PE12-019

2002-2004 Tribute Accelerator  
Cable Recall 2704L

**2002-2004 Tribute  
Accelerator Cable  
Safety Recall [2704L]**

Safety Recall 2704L for 2002-2004 Tribute Accelerator Cable has been revised to add a CAUTION note to the repair procedure, to help prevent damage to the speed control cable while performing the accelerator cable replacement procedure.

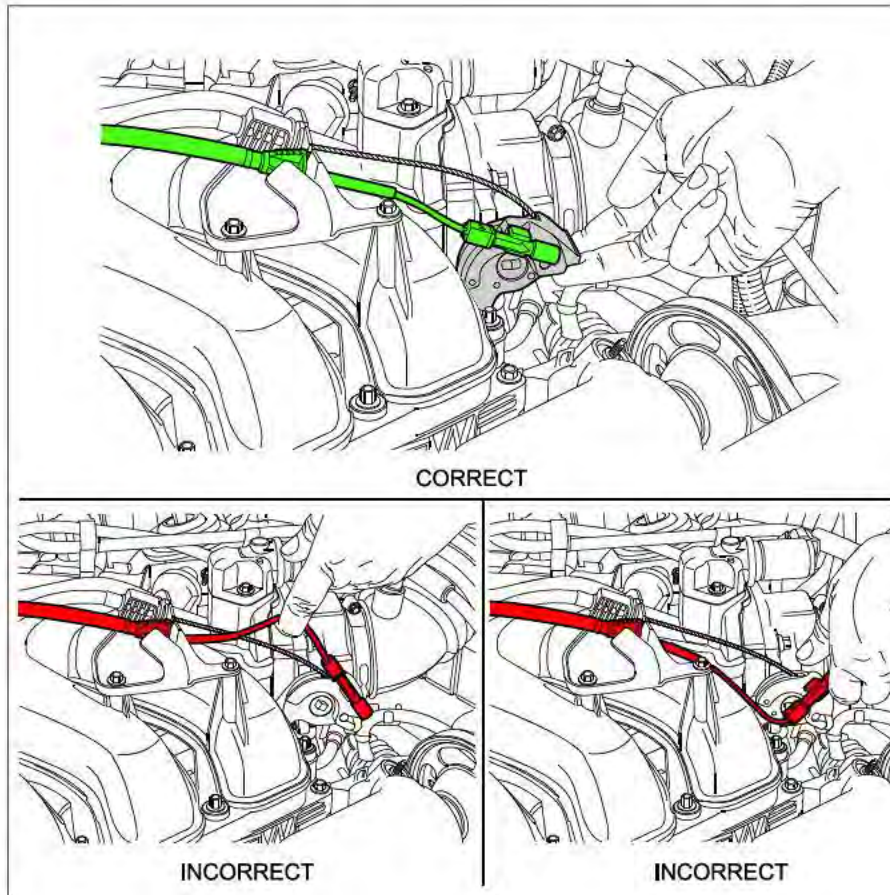
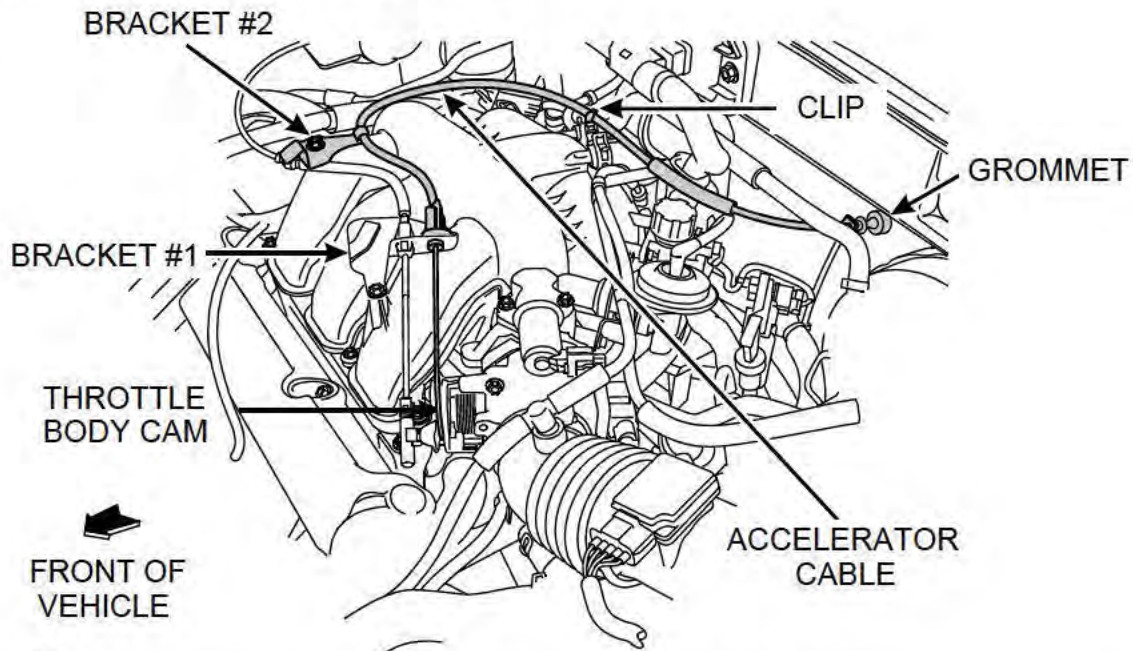
**A CAUTION has been added to the Repair Procedure (Attachment II) to help prevent damage to the speed control cable while performing the accelerator cable replacement procedure.**

- A CAUTION has been added to the Repair Procedure on page 3 to help prevent damage to the speed control cable while performing the accelerator cable replacement procedure.

**CAUTION:** Damage to the speed control cable may result if the throttle body cam is rotated by lifting up on the speed control cable or the speed control cable connector end. When disconnecting the accelerator cable from the throttle body, rotate the throttle body cam only by lifting up on the cam itself. See Figure below.
